寄件者: sun wo wong <[REDACTED]>
寄件日期: 2026年10月16日星期五 15:01
收件者: Adrian Tsz Hin TAM/PLAND; tpbpd/PLAND; Sheren Si Wai LEE/PLAND; Johnny Chung Yin LAM/PLAND
主旨: A/NE-TKL/839
附件: 坪輦 DD76 喉轆場 FS Drawing 16102026.pdf; 回應DSD在 25-08-2026的提問.pdf
類別: Internet Email

Comments from DSD General Comments

PROJECT : Proposed Temporary Rural Workshop (Furniture Processing) with Ancillary Warehouse for a Period of 3 Years at Lots 2264 and 2265 (Part) in D.D. 76, Ta Kwu Ling, New Territories	DRAWING TITLE : F.S. Notes, Legend, Fire Service Installation Layout Plan			ARCHITECT :	CONSULTANT :	FIRE SERVICE CONTRACTOR : Century Fire Service Engineering Co., Ltd.		NAME	DATE	DRAWING NO : FS-01	REV. 0	
								DRAWN BY	C.K.NG	16 Oct 2026	SCALE : 1:500 @ A3	
								CHECKED BY			SOURCE : B.O.O. Ref. BD F.S.D. Ref. FP	
								APPROVED BY				
		REV	DESCRIPTION				DATE

15 drainage layout plan refers:

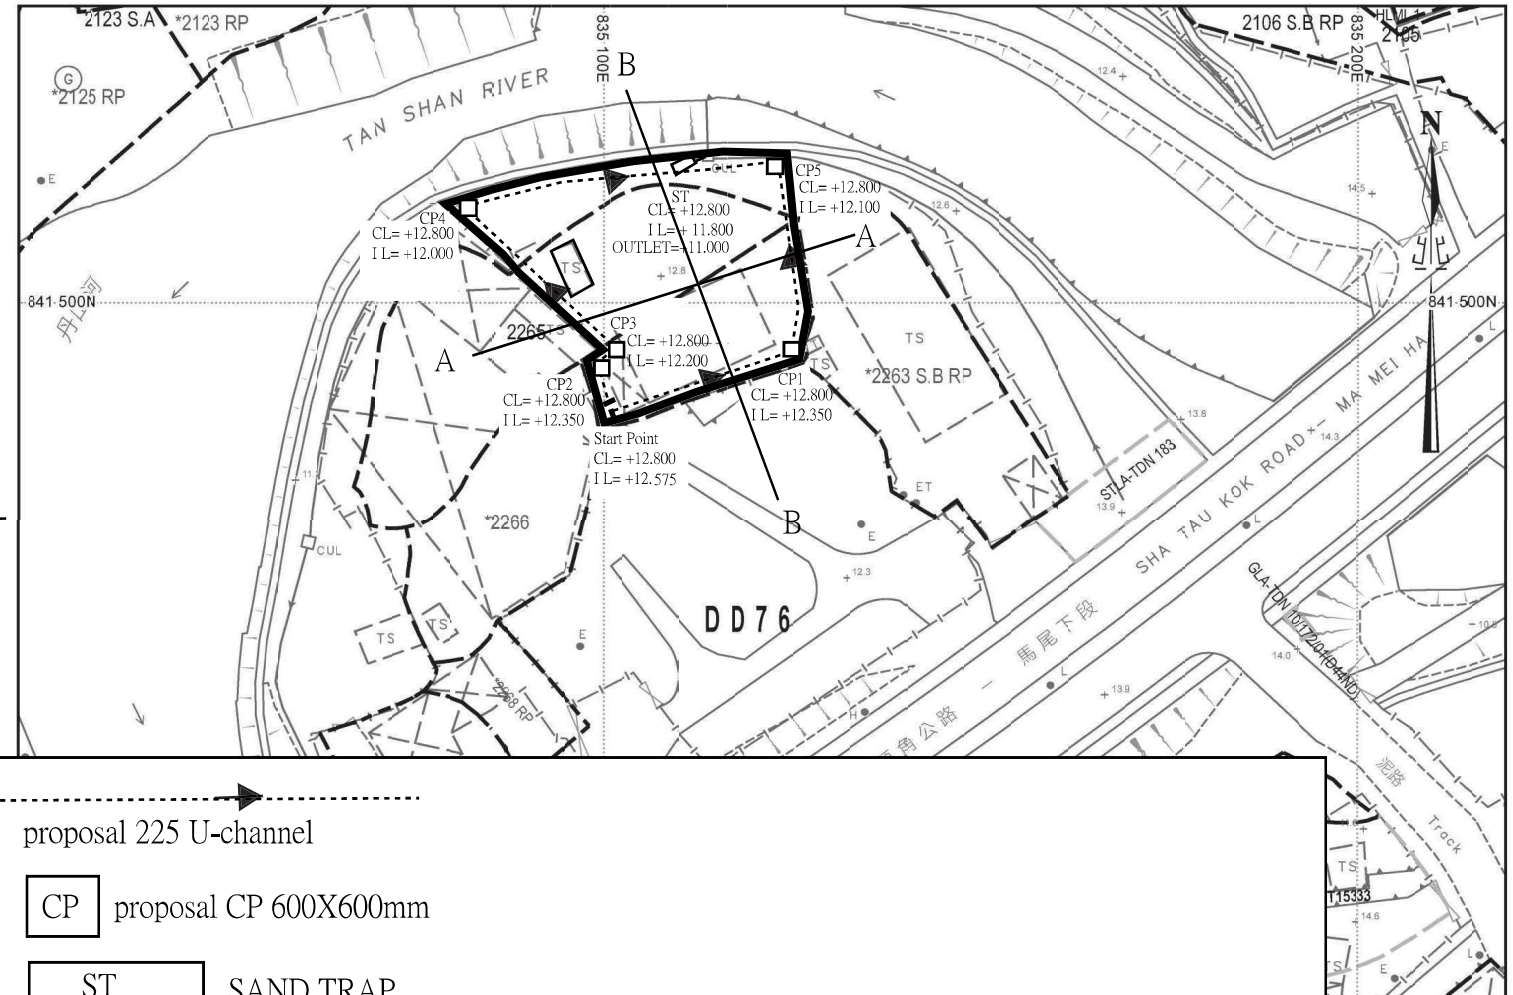
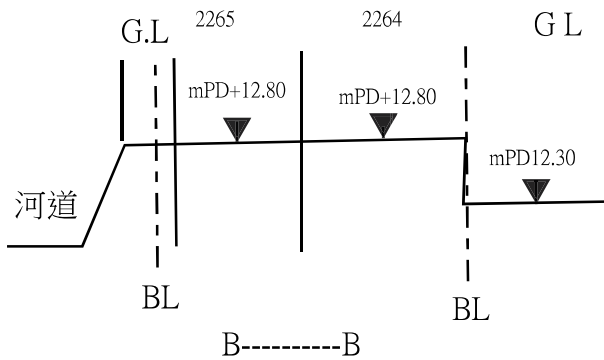
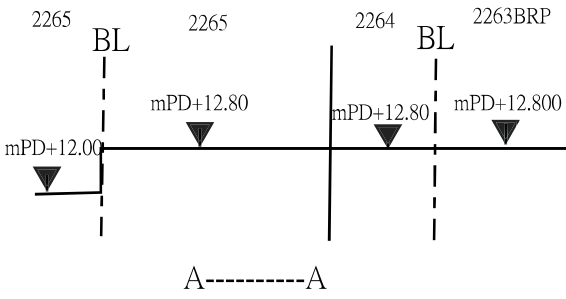
- (a) the applicant should clarify whether the UC downstream to CP4 is connected to ST or CP5;

- (b) the applicant should clarify whether the UC downstream to CP5 is connected to ST;

- (c) the applicant should indicate the details of drainage facility connecting ST and the existing culvert. Typical details of the connection between the proposed drainage facility and the existing culvert should be supplemented;

- (d) thickness of concrete cover/grating should be considered when determining the invert levels of catch pits and u-channels to ensure the depths of u-channels are adequate. For instance, the depth of 225UC at the start point is less than 225mm. The applicant should review;

- (e) catchpit CP19 with desilting facility is not found. The applicant should advise; and

因隔沙井在 CP4 及 CP5 之間，因此兩邊渠道都會直至進入隔沙井。

因隔沙井在 CP4 及 CP5 之間，因此兩邊渠道都會直至進入隔沙井。

隋函附上大樣圖給貴會審議。

有關的錯誤以作更正，及在新一份設計圖內。

設計圖並沒有 CP19，可能在打印時出錯。

雨水渠，沙井及隔沙池大樣圖

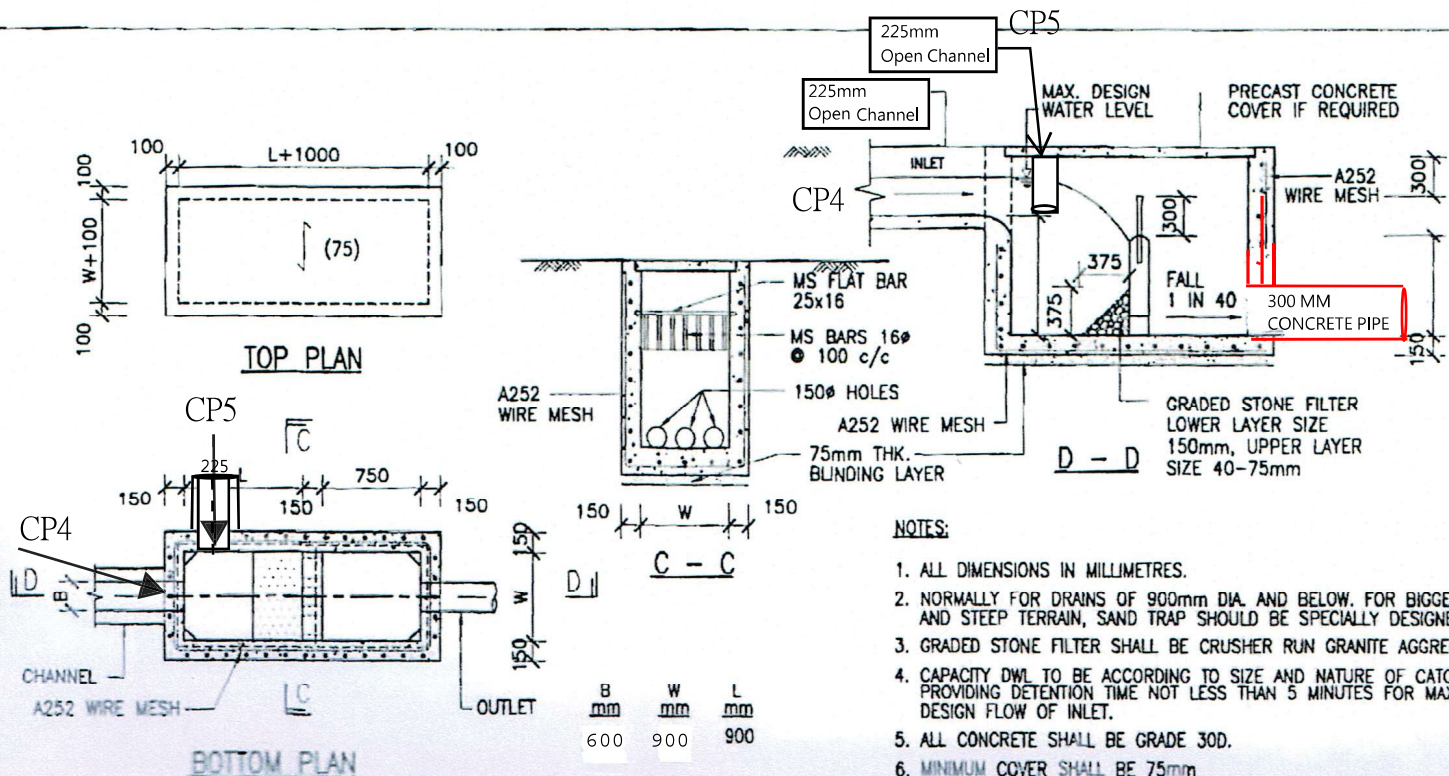
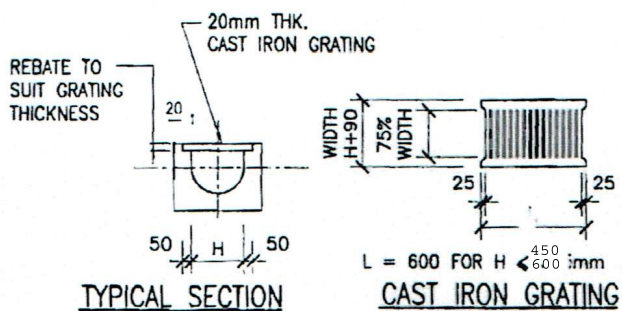
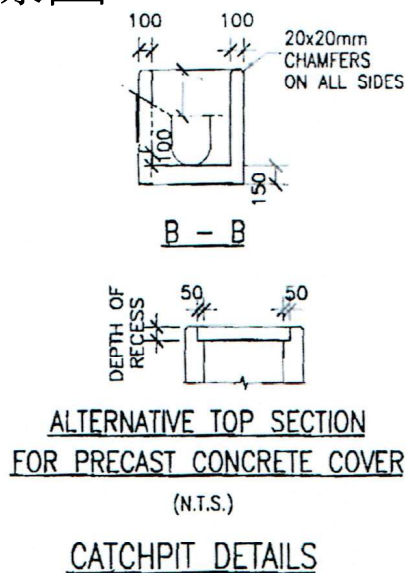
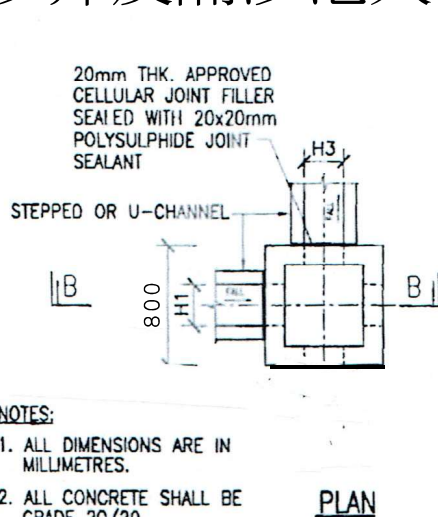
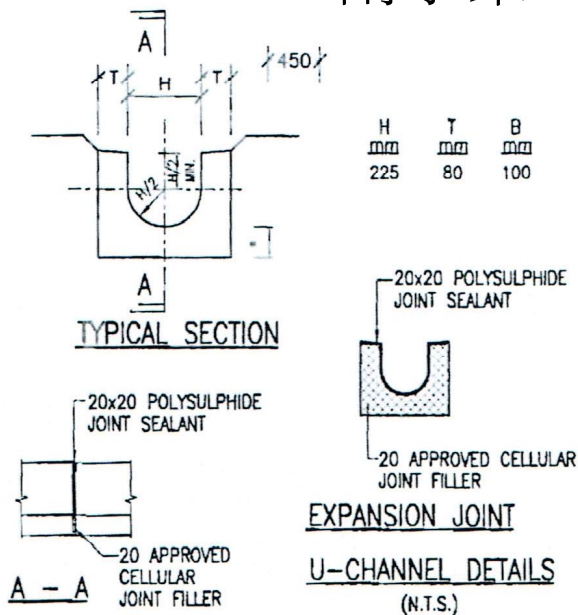
16 there are existing 300UC and culvert maintained by DSD within the subject site. The applicant should advise whether these facilities would be modified or removed; and the applicant should supplement typical details of the proposed sand trap cover for catch pit.

我等並沒有更改政府的排水渠，及隋函附上大樣圖給貴會審議。
